# UNITED STATES PATENT AND TRADEMARK OFFICE

APPLICATION NO.	FILING DATE	FIRST NAMED INVENTOR	ATTORNEY DOCKET NO.	CONFIRMATION NO.
10/752,548	01/08/2004	Dong Won Kim	2832-0174P	6105
2292 7590 04/24/2007 BIRCH STEWART KOLASCH & BIRCH PO BOX 747 FALLS CHURCH, VA 22040-0747			EXAMINER MULLINS, BURTON S	
			ART UNIT	PAPER NUMBER
			2834

## Office Action Summary

Sheet 3 of 4

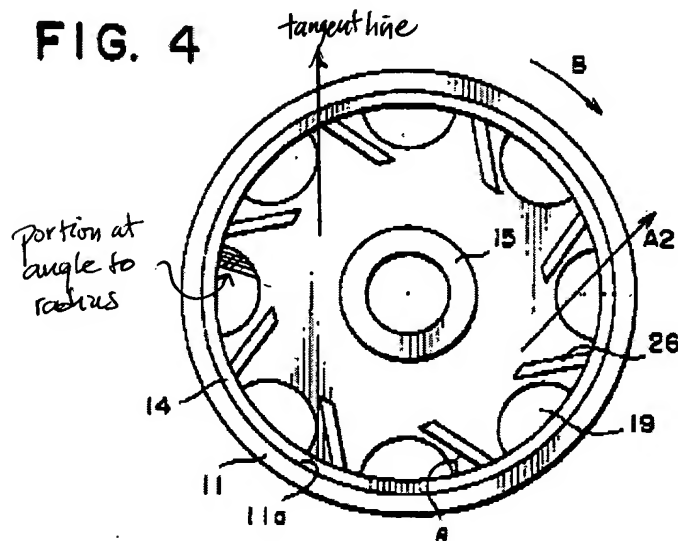
6. Claims 1, 3-6 and 8-11 are rejected under 35 U.S.C. 102(a/e) as being anticipated by Yokota (US 7,078,841). Yokota teaches a motor comprising: a stator; a rotor (i.e., permanent magnet) 12 rotatably disposed around the stator 17 (Figs.1&3); and a rotor cup 11 having cooling-holes (through holes) 19 formed at the bottom part (bottom wall) 11b thereof for

allowing external air to flow into the inside of the rotor cup therethrough (Fig.3), and lower blades 16/26 formed at the bottom part 11b thereof for generating a blowing force (Fig.1&4), the rotor 11 being fixed to the rotor cup 12 at the inner circumference thereof (Figs.1&3), wherein the lower blades 16/26 and the cooling-holes 19 are formed such that each of the lower blades 16/26 and the cooling-holes 19 is "at a prescribed angle to the radial direction of the rotor cup" [sic], i.e. as seen in Fig.4 the lower blades 26 extend at an angle to the radial direction, as does each cooling-hole since a portion of each semicircular cooling-hole is at an angle to the radius, or alternatively a tangent line of the cooling-hole semicircle may be chosen which is at an angle to the radius.

Regarding claims 3 and 5, the rotor 11 is provided at the upper side 11a thereof with upper blades (not numbered, upper edge of L-shaped fins 16; Fig.2; c.4:22-33) for supplying external air to the upper part of the rotor when the rotor is rotated.

Regarding claims 4 and 8-9, the rotor cup is provided at the circumference thereof with vents (portion of through-hole 19 in peripheral wall 11a; c.4:5-9; Figs.2&3) for allowing the air introduced into the inside of the rotor cup to be discharged therethrough.

Regarding claim 6, the upper blades of the fins 26 embodiment of Fig.4 are at a prescribed angle to the radial direction.

Regarding claim 10, the vents 19 are disposed below the rotor (magnets) 12 (Fig.2).

Regarding claim 11, the vents 19 are arranged in large numbers at the circumference of the rotor cup in the circumferential direction (portion of through-hole 19 in peripheral wall 11a; c.4:5-9; Figs.2&3).

8. Claims 2, 7 and 12 are rejected under 35 U.S.C. 103(a) as being unpatentable over Yokota. Yokota teaches sloping lower blades (fins) 26 in the embodiment of Fig.4 but does not specify that “each of the lower blades has an acute sloping angle to the line extended in the rotating direction of the rotor cup and perpendicular to the radial direction of the rotor cup”. However, Yokota does recognize that “by adjusting the angle  $\theta$  formed between the fin 26 and the inner peripheral surface of the flywheel 11...the effect or action of the air currents or flows can be regulated” (Fig.4; c.6:18-21). It would have been obvious to modify Yokota to provide

each lower blades 16 with an acute sloping angle to the line extended in the rotating direction of the rotor cup and perpendicular to the radial direction of the rotor cup since this would have regulated the air currents in the machine.

Regarding claim 12, the ratio between the area of a cooling-hole (i.e., axial-facing portion of through-hole 19) and the area of a circumferential vent (portion of through-hole 19 in peripheral wall 11a; c.4:5-9; Figs.2&3) is not specifically taught by Yokota to be in the range of 2:1 to 4:1. However, it is clear from Figs.2&3 that the circumferential area is generally less than the axial-facing area. A range of ratios between 2:1 and 4:1 would have been an obvious matter of engineering design since it has been held that where the general conditions of a claim are met, discovering optimum or workable ranges involves only routine skill. In re Aller, 105 USPQ 233.
